ARCHITECT'S ADDENDUM

Addendum Number: 004

RE: EASD #131 East Aurora High School
2027 Mechanical Improvements

Subject: Addendum No. 004 to the Construction Documents for the EASD #131 East Aurora High School 2027 Mechanical Improvements Project.

3 AXON DETAIL - ROOF SYSTEM #1 (FULL REPLACEMENT MOD BIT)
1 1/2" = 1'-0"

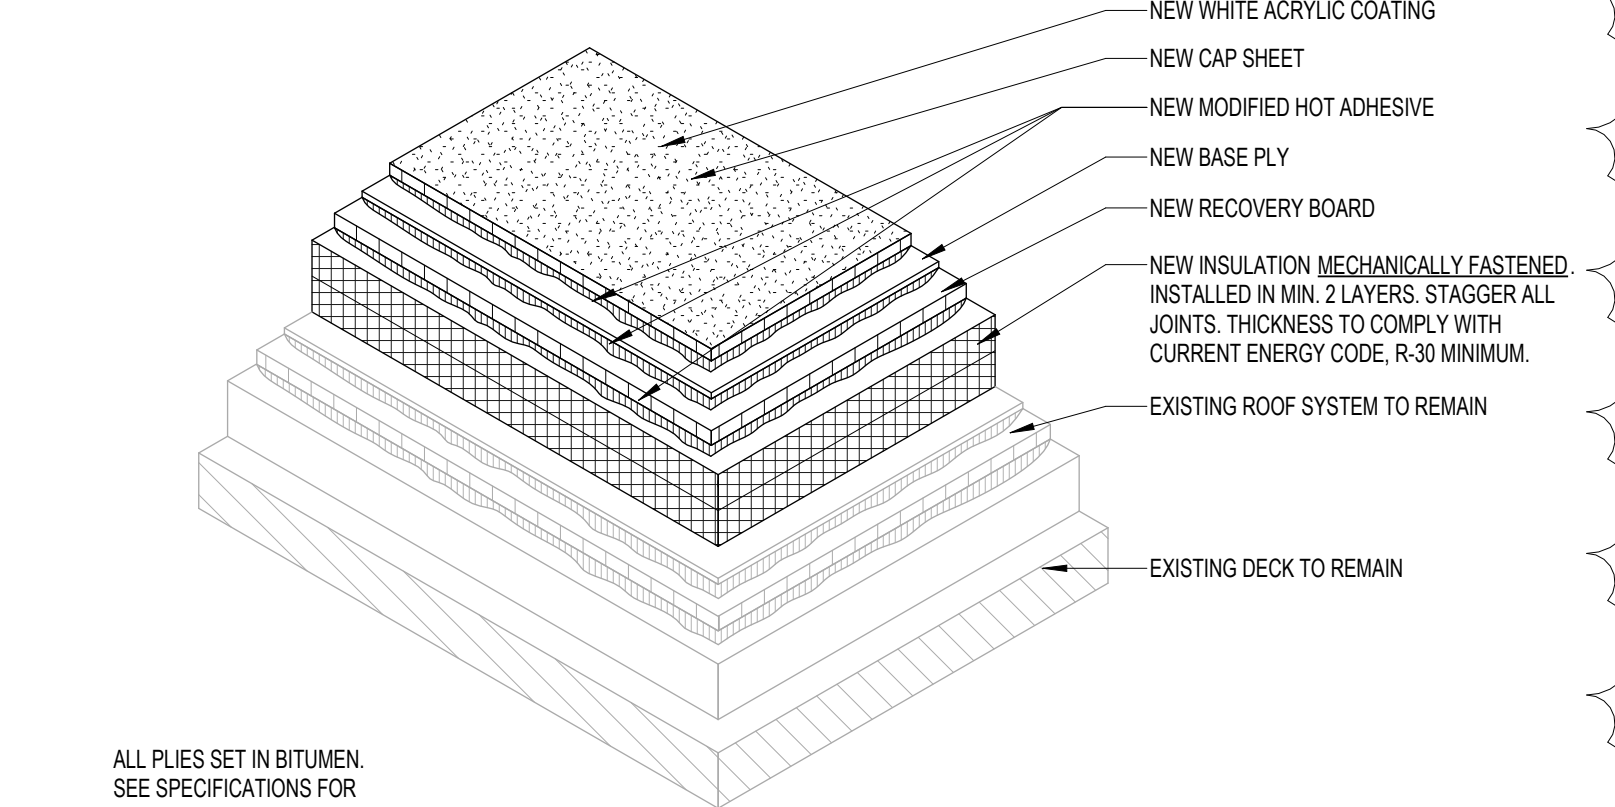
- **REPLACE** sheet in its entirety.
- **ADDED** Axon Detail 3/R-4.11 – Roof System #1 (Full Replacement Mod Bit)
- **ADDED** Axon Detail 4/R-4.11 – Roof System #2 (Mod Bit Over Build)
- **ADDED** Axon Detail 5/R-4.11 – Roof System #3 (EPDM Restoration Coat)
- **REVISED** Demolition Keynotes
- **ADDED** New Roof Construction Legend
- **REVISED** New Work Keynotes – Alternates
- **ADDED** Existing Conditions Photos
